PROJECT:	Nebraska State Patrol Crime Lab	PROJECT NO.	#L13459
FROM:	BVH Architects	DATE:	7/15/14
TO:	Bidders	ADDENDUM NO.	#3

ADDENDUM NO. CC-3

NEBRASKA STATE CRIME LAB
LINCOLN, NEBRASKA
DLR GROUP PROJECT NO. 10-13212-00

ADDENDUM NO. 3

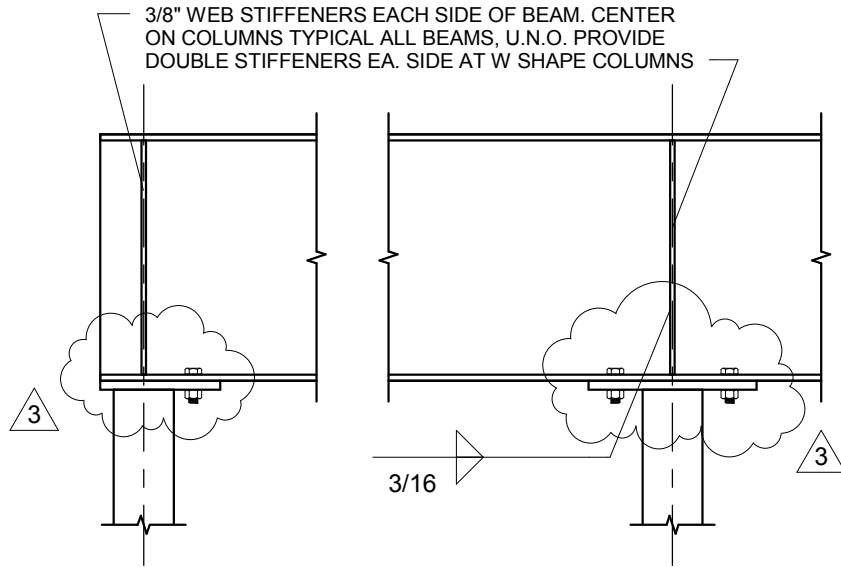
1. See attached drawing labeled sheet 1 from Alfred Benesch and Company for information regarding parking lot security gate.

PROVIDE DISCONNECT

PROVIDE 120V OUTLET

GATE OPERATOR

OSCO GSLG OPRATOR, 1 HP, 208V WITH AUXILIARY LIMIT & HEATER BOX.

CARD READER

SEE ELECTRICAL DRAWINGS FOR CARD READER SPECIFICATIONS.

145 TYP SLAB-ON-GRADE JOINTS
 A0.1-TI SCALE: 1 1/2" = 1'-0"

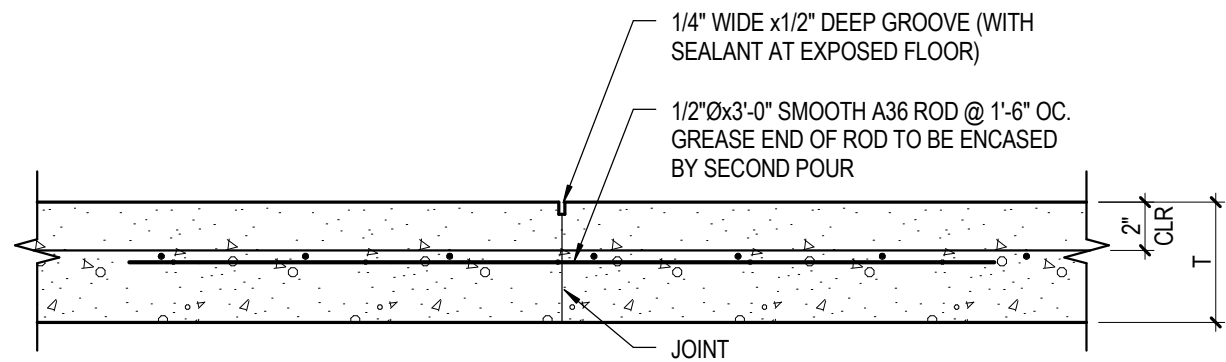
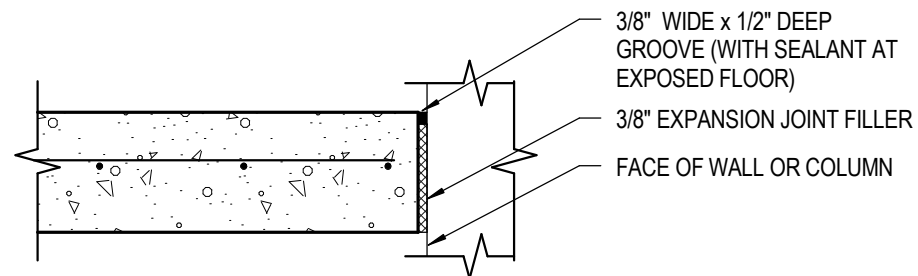
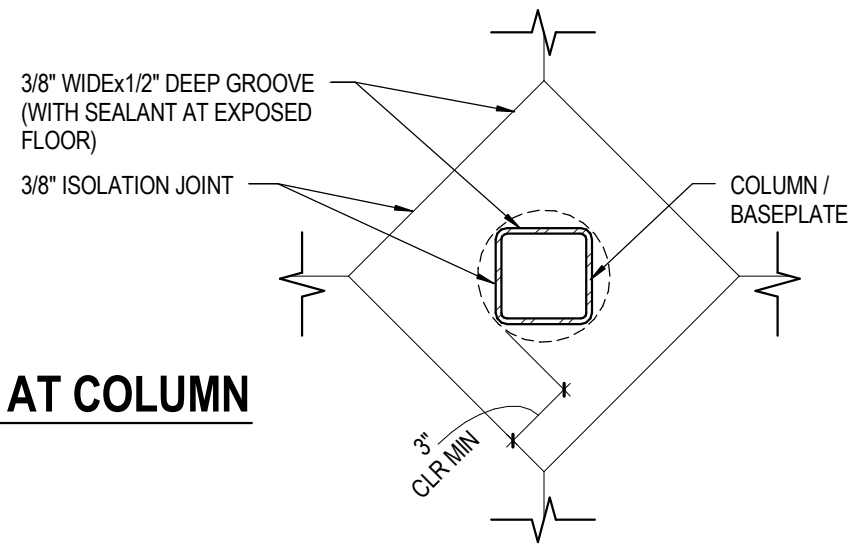
- A. Add Attachment A0 to Sheet A0.1-TI

A CONTROL (CONTRACTION) JOINT (CJ)

B CONSTRUCTION JOINT (CONST JT)

C ISOLATION JOINT (IJ)

D ISOLATION JOINT AT COLUMN

NOTE: TYPICAL SLAB CONDITION
 4" CONCRETE SLAB-ON GRADE WITH
 6"x6" - W1.4XW1.4 WWF OVER VAPOR
 BARRIER ON GRANULAR FILL.
 THICKENED SLAB (8") AT BUILDING PERIMETER
 TYP FINISH FLOOR EL=100'-0"
